AMERICANS WITH DISABILITY
ACT (ADA) FACILITY
ASSESSMENT REPORT

Americans with Disabilities Act (ADA) Facility Barrier Report

July 2024

Red Sunset Park

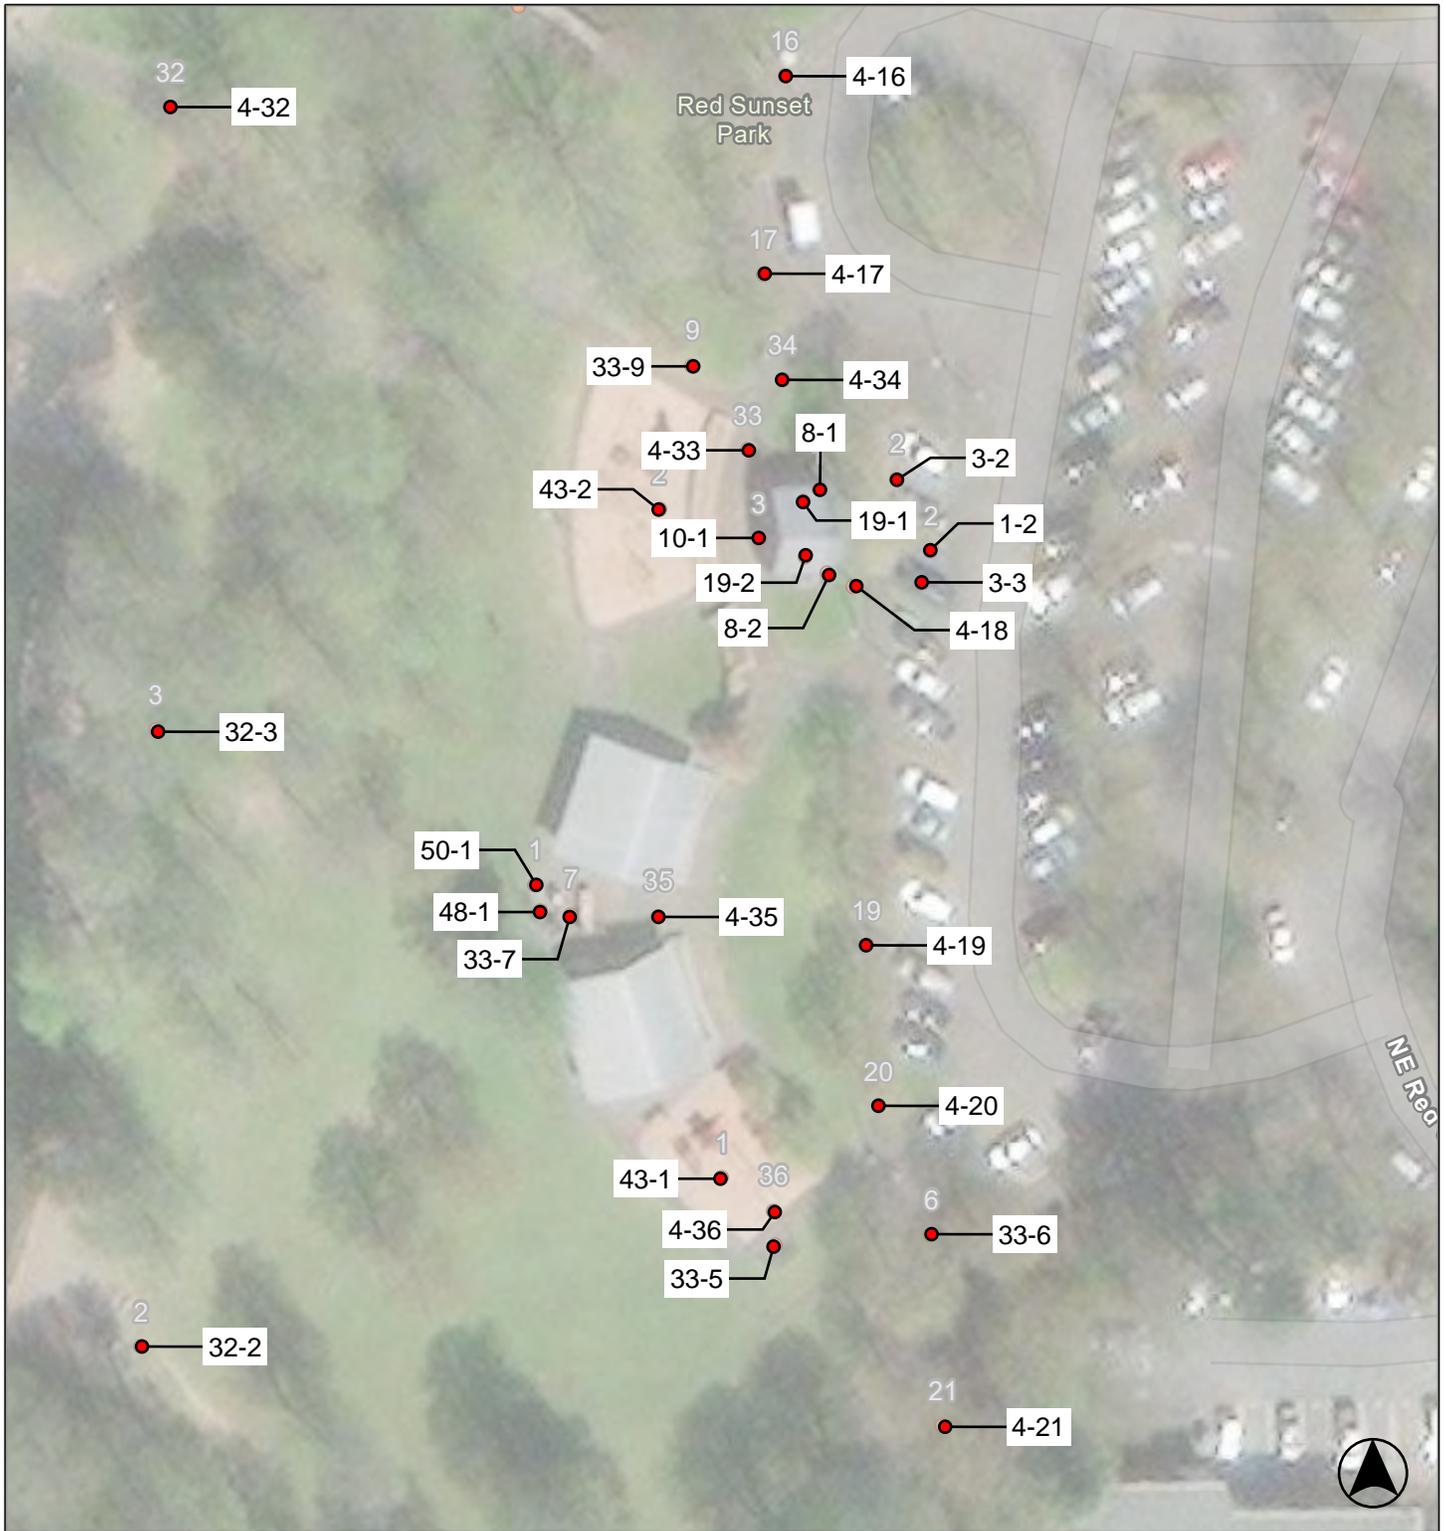
Park	
1 - 1	Parking Area Category: 1
Install van accessible sign	\$1,750
Notes: A "Van Accessible" sign is not provided ("Van Accessible" sign that is 18" wide by 9" high on a white retroreflective background and green retroreflective lettering provided at each van accessible space).	
ADA: 208.2.4, 502.6	
Other: OSSC 1106.7	
Regrade accessible parking space or access aisle	\$4,050
Notes: Slopes of accessible parking space and access aisle are up to 2.9% (2.0% max).	
ADA: 502.4	
Other: -	
Provide adequate striping	\$180
Notes: The words "No Parking" are not painted in the access aisle.	
ADA: -	
Other: OSSC 1106.7	
1 - 2	Parking Area Category: 1
Install van accessible sign	\$1,750
Notes: A "Van Accessible" sign is not provided ("Van Accessible" sign that is 18" wide by 9" high on a white retroreflective background and green retroreflective lettering provided at each van accessible space).	
ADA: 208.2.4, 502.6

Other: OSSC 1106.7	
Regrade accessible parking space or access aisle	\$4,050
Notes: Slopes of accessible parking space and access aisle are up to 3.4% (2.0% max).	
ADA: 502.4	
Other: -	
Provide adequate striping	\$180
Notes: The words "No Parking" are not painted in the access aisle.	
ADA: -	
Other: OSSC 1106.7	
Provide a pavement stencil	\$310
Notes: International symbol of accessibility pavement stencil is not provided. (28" high min, 24" wide min, painted with a 3" min stroke width of retroreflective white paint on an optional blue retroreflective background). ISA provided is faded and not retroreflective.	
ADA: -	
Other: OSSC 1106.7

Park	
3 - 1	Curb Ramp Category: 1
Grind or patch vertical change of grade	\$320
Notes: Curb ramp has a surface level change of 3/4" due to at transition (curb ramp must be free of level changes).	
ADA: 405.4	
Other: -	
Install, replace or modify curb ramp	\$17,150
Notes: Slope of the curb ramp is 8.8% (8.33% max).	
ADA: 405.2, 406.1	
Other: -	
Provide detectable warnings	\$1,270
Notes: Detectable warning surface does not contrast visually with adjacent walking surfaces (light-on-dark or dark-on-light).	
ADA: 705.1	
Other: -	
Reduce or eliminate opening	\$300
Notes: A horizontal gap across the ramp is greater than 1/2" wide (1/2" max).	
ADA: 302.3	
Other: -	
3 - 2	Curb Ramp Category: 1
Reduce or eliminate opening	\$300
Notes: A horizontal gap across the ramp is 1" wide (1/2" max).	
ADA: 302.3	
Other: -	
Provide detectable warnings	\$1,270
Notes: Detectable warning surface does not contrast visually with adjacent walking surfaces (light-on-dark or dark-on-light).

Park	
3 - 3	Curb Ramp Category: 1
Reduce or eliminate opening	\$300
Notes: A horizontal gap across the ramp is 1" wide (1/2" max).	
ADA: 302.3	
Other: -	
Provide detectable warnings	\$1,270
Notes: Detectable warning surface does not contrast visually with adjacent walking surfaces (light-on-dark or dark-on-light).	
ADA: 705.1	
Other: -	
4 - 1	Walk Category: 1
Regrade surface	\$4,700
Notes: Running slope of concrete is up to 7.1% for 47 linear feet (5.0% max).	
ADA: 403.3	
Other: -	
4 - 2	Walk Category: 1
Reduce or eliminate opening	\$300
Notes: Gap at cracks in concrete is greater than 1/2" (1/2" max).	
ADA: 302.3	
Other: -	
4 - 3	Walk Category: 1
Reduce or eliminate opening	\$300
Notes: Gap at cracks in concrete is greater than 1/2" (1/2" max).	
ADA: 302.3	
Other: -	
4 - 4	Walk Category: 1
Reduce or eliminate opening	\$300
Notes: Gap at cracks in concrete is greater than 1/2" (1/2" max).	
ADA: 302.3	
Other: -	
Regrade surface	\$6,300

Citizen Comment: There should be a curb ramp at this marked crosswalk.

Park	
4 - 26	Walk Category: 1
Regrade surface	\$8,100
Notes: Cross slope of concrete is up to 6.6% for 81 linear feet (2.0% max).	
ADA: 403.3	
Other: -	
Grind or patch vertical change of grade	\$100
Notes: Surface level change in path is greater than 1/4" (1/4" max; up to 1/2" with a 1:2 bevel)	
ADA: 303.2, 303.3	
Other: -	
4 - 27	Walk Category: 1
Reduce or eliminate opening	\$600
Notes: Gap at cracks in concrete is greater than 1" (1/2" max).	
ADA: 302.3	
Other: -	
Regrade surface	\$5,000
Notes: Cross slope of concrete is up to 4.7% for 50 linear feet (2.0% max).	
ADA: 403.3	
Other: -	
4 - 28	Walk Category: 1
Reduce or eliminate opening	\$600
Notes: Gap at cracks in concrete is greater than 1" (1/2" max).	
ADA: 302.3	
Other: -	
Grind or patch vertical change of grade	\$200
Notes: Surface level change is greater than 1/4" due to cracks (1/4" max; up to 1/2" with a 1:2 bevel).	
ADA: 303.2, 303.3	
Other: -	
4 - 29	Walk Category: 1

Park	
4 - 30	Walk Category: 1
Reduce or eliminate opening	\$600
Notes: Gap at cracks in concrete is greater than 1/2" (1/2" max).	
ADA: 302.3	
Other: -	
4 - 31	Walk Category: 1
Regrade surface	\$9,200
Notes: Running slope of path to bridge is up to 7.1% (5.0% max).	
On the bridge, the run slope was up to 6.5% and cross slope of 4.3% (2.0% max).	
Total segment length for 92 linear feet.	
ADA: 403.3	
Other: -	
Grind or patch vertical change of grade	\$100
Notes: Surface level change in path is greater than 1/4" (1/4" max; up to 1/2" with a 1:2 bevel)	
ADA: 303.2, 303.3	
Other: -	
4 - 32	Walk Category: 1
Regrade surface	\$13,200
Notes: Running slope of path from bridge is up to 10.5% (5.0% max). Cross slope on path of 4.3% (2.0% max).	
Total segment length is 132 linear feet.	
ADA: 403.3	
Other: -	
Grind or patch vertical change of grade	\$300
Notes: Surface level change in path is greater than 1/4" (1/4" max; up to 1/2" with a 1:2 bevel).

Surface level change on bridge is greater than 1" (1/4" max; up to 1/2" with a 1:2 bevel). (x2)	
ADA: 303.2, 303.3	
Other: -

Park	
4 - 33	Walk Category: 1
Regrade surface	\$3,500
Notes: Cross slope of in front of the dedication plaque is up to 3.0% for 10 linear feet (2.0% max).	
Cross slope around the playground is up to 3.8% for 25 linear feet (2.0% max).	
ADA: 403.3	
Other: -	
Grind or patch vertical change of grade	\$100
Notes: Tripping hazard in the walkway (1/4" max; up to 1/2" with a 1:2 bevel)	
ADA: 303.2, 303.3	
Other: -	
Reduce or eliminate opening	\$2,400
Notes: Gap at concrete joint is greater than 1/2" (1/2" max). (x8)	
ADA: 302.3	
Other: -	
4 - 34	Walk Category: 1
Regrade surface	\$1,000
Notes: Running slope of concrete is up to 5.5% for 10 linear feet (5.0% max).	
ADA: 403.3	
Other: -	
4 - 35	Walk Category: 1
Reduce or eliminate opening	\$1,200
Notes: Gap at concrete joints in front of the sink and shelter is greater than 1/2" (1/2" max). (x4)	
ADA: 302.3	
Other: -	
4 - 36	Walk Category: 1
Reduce or eliminate opening	\$300

Park	
8 - 1	Door/Gate Category: 1
Provide or modify door kick plate	\$350
Notes: A smooth and uninterrupted kick plate surface is not provided. A doorstop is located in the 10" space above the finish floor.	
ADA: 404.2.10	
Other: -	
Adjust door closer	\$160
Notes: Door closer sweep time is less than the five second minimum from 90 degrees to 12 degrees.	
Door opening force is 8 lbs (5 lbs max).	
ADA: 404.2.8.1, 404.2.9	
Other: OSSC 1102.1.2.5	
Enlarge door opening	\$4,650
Notes: Height of clear opening is 77" AFF (80" min). The mag lock protrudes into the head clearance.	
ADA: 404.2.3	
Other: -	
Reduce or eliminate opening	\$300
Notes: Gaps and cracks in the the landing/threshold create openings greater than 1/2" (1/2" max).	
ADA: 302.3	
Other: -	
Provide strike edge clearance	\$3,180
Notes: The push side clearance is obstructed by the lightswitch box and is less than 8" (8" min).	
ADA: 404.2.4.3	
Other: -

Park		
8 - 2	Door/Gate	Category: 1
Provide or modify door kick plate		\$350
Notes: A smooth and uninterrupted kick plate surface is not provided. A doorstop is located in the 10" space above the finish floor.		
ADA: 404.2.10		
Other: -		
Adjust door closer		\$160
Notes: Door closer sweep time is less than the five second minimum from 90 degrees to 12 degrees.		
Door opening force is 12 lbs (5 lbs max).		
ADA: 404.2.8.1, 404.2.9		
Other: OSSC 1102.1.2.5		
Enlarge door opening		\$4,650
Notes: Height of clear opening is 78" AFF (80" min). The mag lock protrudes into the head clearance.		
ADA: 404.2.3		
Other: -		
Reduce or eliminate opening		\$300
Notes: Gaps and cracks in the the landing/threshold create openings of 5/8" (1/2" max).		
ADA: 302.3		
Other: -		
10 - 1	Drinking Fountain	Category: 3
Confirm water flow compliance		\$0
Notes: Water service to the drinking fountain was disconnected at the time of the assessment. Flow height and angle could not be confirmed.

ADA: 602.3, 602.6		
Other: -		
10 - 2	Drinking Fountain	Category: 3
Confirm water flow compliance		\$0
Notes: Water service to the drinking fountain was disconnected at the time of the assessment. Flow height and angle could not be confirmed.		
ADA: 602.3, 602.6		
Other: -		
Increase or provide maneuvering or clear floor area		\$1,270
Notes: The clear floor space has a greater than 1/2" gap in the pavement (1/2" max).		
ADA: 305.1, 305.2, 305.3, 305.5, 306.1		
Other: -

Park	
10 - 3 Drinking Fountain	Category: 3
Confirm water flow compliance	\$0
Notes: Water service to the drinking fountain was disconnected at the time of the assessment. Flow height and angle could not be confirmed.	
ADA: 602.3, 602.6	
Other: -	
Increase or provide maneuvering or clear floor area	\$1,270
Notes: The clear floor space has a trench drain with 5" slots, creating openings (1/2" max).	
ADA: 305.1, 305.2, 305.3, 305.5, 306.1	
Other: -

Park	
19 - 1 Multiple User Restroom	Category: 2
Install restroom sign	\$250
Notes: A tactile and braille restroom sign is not provided. Women's restroom side.	
ADA: 216.2, 216.8	
Other: -	
Insulate water lines	\$160
Notes: The lavatory drain pipes are not insulated.	
ADA: 606.5	
Other: -	
Reposition clothing hooks	\$160
Notes: The coat hook in the accessible compartment is more than 48" AFF (48" max).	
ADA: 308.1	
Other: -	
Provide or replace compartment door hardware	\$550
Notes: Water closet compartment door is not self-closing.	
The door is not on the corner furthest from the water closet.	
ADA: 604.8.1.2	
Other: -	
Modify stall partitions	\$650
Notes: Clear width over water closet is 45" (60" min) to the wall.	
ADA: 604.3.1	
Other: -	
Reposition toilet flush controls	\$160
Notes: Flush control is not located on wide side of the water closet (flush control is required to be located on the open side of the fixture).

ADA: 604.6	
Other: -	
Replace or modify grab bars	\$480
Notes: A rear and vertical grab bar are not provided.	
The side grab bar is 41" long (42" min) and ends less than 54" from the rear wall (54" min).	
ADA: 604.5.1, 604.5.2	
Other: A117.1 604.5.1.2

Park	
19 - 1 Multiple User Restroom	Category: 2
Replace or reposition dispenser	\$160
Notes: The toilet paper is 7" above the side grab bar (12" min).	
ADA: 604.7	
Other: -	
Replace toilet or adjust toilet seat height	\$2,850
Notes: Water closet seat height is 19-1/2" AFF (17" min to 19" max).	
ADA: 604.4	
Other: -

Park	
19 - 2 Multiple User Restroom	Category: 2
Install restroom sign	\$250
Notes: A tactile and braille restroom sign is not provided. Men's restroom side.	
ADA: 216.2, 216.8	
Other: -	
Insulate water lines	\$160
Notes: The lavatory drain pipes are not insulated.	
ADA: 606.5	
Other: -	
Provide or replace compartment door hardware	\$550
Notes: Water closet compartment door does not interior or exterior handles.	
ADA: 604.8.1.2	
Other: -	
Modify stall partitions	\$650
Notes: Clear width over water closet is 47" (60" min) to the wall.	
ADA: 604.3.1	
Other: -	
Reposition toilet flush controls	\$160
Notes: Flush control is not located on wide side of the water closet (flush control is required to be located on the open side of the fixture).	
ADA: 604.6	
Other: -	
Replace or modify grab bars	\$480
Notes: A rear and vertical grab bar are not provided.	
The side grab bar extends to 53" from the rear wall (54" min).	
ADA: 604.5.1, 604.5.2

Other: A117.1 604.5.1.2	
Replace or reposition dispenser	\$160
Notes: The centerline of the toilet paper in front of the water closet is 13" (7" min and 9" max).	
ADA: 604.7	
Other: -	
Replace urinal	\$2,385
Notes: Height of the urinal rim is 19" AFF (17" max).	
ADA: 605.2	
Other: -

Park	
19 - 2 Multiple User Restroom	Category: 2
Replace or reposition fixtures	\$1,590
Notes: The centerline of the water closet is 18-1/2" from the wall (16" min to 18" max).	
ADA: 604.2	
Other: -	
Replace or adjust water controls	\$640
Notes: Water flows from the lavatory faucet for 4 seconds (10 seconds min).	
Operating effort of lavatory faucet is 8 lbs (5 lbs max).	
ADA: 309.1, 606.4	
Other: -	
29 - 1 Game and Sports Area	Category: 2
Provide wheelchair seating	\$3,600
Notes: No wheelchair spaces are provided near the approximately 50 spectator bleacher seats (2 wheelchair spaces min for 26 to 50 seats). (x2 sets of bleachers)	
ADA: 221.2.1.1	
Other: -	
Provide wheelchair seating	\$1,800
Notes: No wheelchair spaces provided in team seating areas (two min - one per team space).	
ADA: 221.2.1.4	
Other: -	
32 - 1 Picnic Area	Category: 2
Provide an accessible table	\$3,250
Notes: Knee clearance measured 8" horizontally from the front face of the table top is 25" (27" min).

ADA: -	
Other: ABA 306.3	
Increase or provide clear floor area	\$200
Notes: There is a 1" gap in the clear floor space of the picnic table (1/2" max).	
ADA: -	
Other: ABA 1011.2.1

Park	
32 - 2 Picnic Area	Category: 2
Provide an accessible route	\$6,400
Notes: An accessible route to the picnic table is not provided. Route is 80 linear feet over grass from the path to picnic area (36" wide min path of travel constructed with an accessible surface).	
ADA: -	
Other: ABA F206.2.2, ABA F245.4	
32 - 3 Picnic Area	Category: 2
Provide an accessible route	\$6,400
Notes: An accessible route to the picnic table is not provided. Route is 80 linear feet over grass from the path to picnic area (36" wide min path of travel constructed with an accessible surface).	
ADA: -	
Other: ABA F206.2.2, ABA F245.4	
Provide an accessible table	\$3,250
Notes: Knee clearance measured 8" horizontally from the front face of the table top is 26" (27" min).	
ADA: -	
Other: ABA 306.3	
32 - 4 Picnic Area	Category: 2
Provide an accessible route	\$1,600
Notes: An accessible route to the picnic table is not provided. Route is 20 linear feet over grass from the path to picnic area (36" wide min path of travel constructed with an accessible surface).

ADA: -	
Other: ABA F206.2.2, ABA F245.4	
Provide an accessible table	\$3,250
Notes: Knee clearance measured 8" horizontally from the front face of the table top is 26" (27" min).	
ADA: -	
Other: ABA 306.3	
Increase or provide clear floor area	\$200
Notes: The clear space around the grill narrows down to 24" (48" min wide).	
ADA: -	
Other: ABA 1011.2.1	
Regrade surface	\$20
Notes: Slope of the clear floor space around the grill is up to 3.9% (2.0% max).	
ADA: -	
Other: ABA 1011.2.3

Park	
32 - 5 Picnic Area	Category: 2
Provide an accessible table	\$3,250
Notes: Knee clearance measured 8" horizontally from the front face of the table top is 26" (27" min).	
ADA: -	
Other: ABA 306.3	
Increase or provide clear floor area	\$200
Notes: The clear space around the grill narrows down to 24" (48" min wide).	
ADA: -	
Other: ABA 1011.2.1	
33 - 1 Outdoor Constructed Features	Category: 3
Increase or provide clear floor area	\$200
Notes: A clear ground space is not provided adjacent to the bench (36" by 48" min).	
ADA: -	
Other: ABA 1011.2.1, ABA 1011.2.3	
33 - 2 Outdoor Constructed Features	Category: 3
Increase or provide clear floor area	\$200
Notes: A clear ground space is not provided adjacent to the bench (36" by 48" min).	
ADA: -	
Other: ABA 1011.2.1, ABA 1011.2.3	
33 - 3 Outdoor Constructed Features	Category: 3
Increase or provide clear floor area	\$200
Notes: There is a greater than 1/2" gap in the pavement in front of the trash container (1/2" max).

ADA: -	
Other: ABA 1011.2	
33 - 4 Outdoor Constructed Features	Category: 3
Increase or provide clear floor area	\$200
Notes: There is a greater than 1" gap between the bench and the trash container (1/2" max).	
ADA: -	
Other: ABA 1011.2	
33 - 5 Outdoor Constructed Features	Category: 3
Increase or provide clear floor area	\$200
Notes: A clear ground space is not provided adjacent to the bench (36" by 48" min). Space is too narrow.	
ADA: -	
Other: ABA 1011.2.1, ABA 1011.2.3

Park	
33 - 6	Outdoor Constructed Features Category: 3
Increase or provide clear floor area	\$200
Notes: Clear ground space adjacent to the bench has a slope of 3.7% (2.0% max).	
ADA: -	
Other: ABA 1011.2.1, ABA 1011.2.3	
33 - 7	Outdoor Constructed Features Category: 3
Replace or reposition picnic grill	\$950
Notes: Cooking surface is 40" above the ground (34" max).	
ADA: -	
Other: ABA 1011.5.2	
33 - 8	Outdoor Constructed Features Category: 3
Increase or provide clear floor area	\$200
Notes: Clear ground space adjacent to the trash can has a slope of 3.7% (2.0% max).	
ADA: -	
Other: ABA 1011.2.1, ABA 1011.2.3	
33 - 9	Outdoor Constructed Features Category: 3
Increase or provide clear floor area	\$200
Notes: A clear ground space is not provided adjacent to the bench (36" by 48" min).	
ADA: -	
Other: ABA 1011.2.1, ABA 1011.2.3	
35 - 1	Other Category: 3
Reposition controls	\$285
Notes: Operating mechanism of dog bag station is 52" above the ground (15" min to 48" max). Dispenser is out of reach range.

ADA: 308.2, 308.2.1	
Other: -	
35 - 2	Other Category: 3
Reposition controls	\$285
Notes: The horizontal reach range is 60" over grass (24" max horizontal reach).	
ADA: 308.2.2	
Other: -	
35 - 3	Other Category: 3
Increase or provide maneuvering or clear floor area	\$200
Notes: Clear floor space of the dog bag stations is not provided (30" by 48" min).	
ADA: 305.2, 305.3, 305.5	
Other: -

Park	
35 - 4	Other Category: 3
Reposition controls	\$285
Notes: Operating mechanism of the dog bag station is 56" above the ground (15" min to 48" max).	
The reach is 32" horizontally and out of reach range (24" max).	
ADA: 308.2, 308.2.1	
Other: -	
43 - 1	Play Equipment Area Category: 2
Improve or evaluate play area surface	\$0
Notes: Ground surface in play area is in need of maintenance and further evaluation of fall attenuation surface is recommended.	
ADA: 1008.2.6.1, 1008.2.6.2	
Other: -	
Regrade or replace ramp	\$540
Notes: The ramp runs connecting ground level play components within the play structure have a slope of 9.1% (6.25% max).	
ADA: 1008.2.5.1	
Other: -	
43 - 2	Play Equipment Area Category: 2
Improve or evaluate play area surface	\$0
Notes: Ground surface in play area is in need of maintenance and further evaluation of fall attenuation surface is recommended.	
ADA: 1008.2.6.1, 1008.2.6.2	
Other: -

Install or modify transfer system	\$6,350
Notes: The transfer step is 8-1/2" high (8" max).	
ADA: 1008.3.2.1, 1008.3.2.2	
Other: -
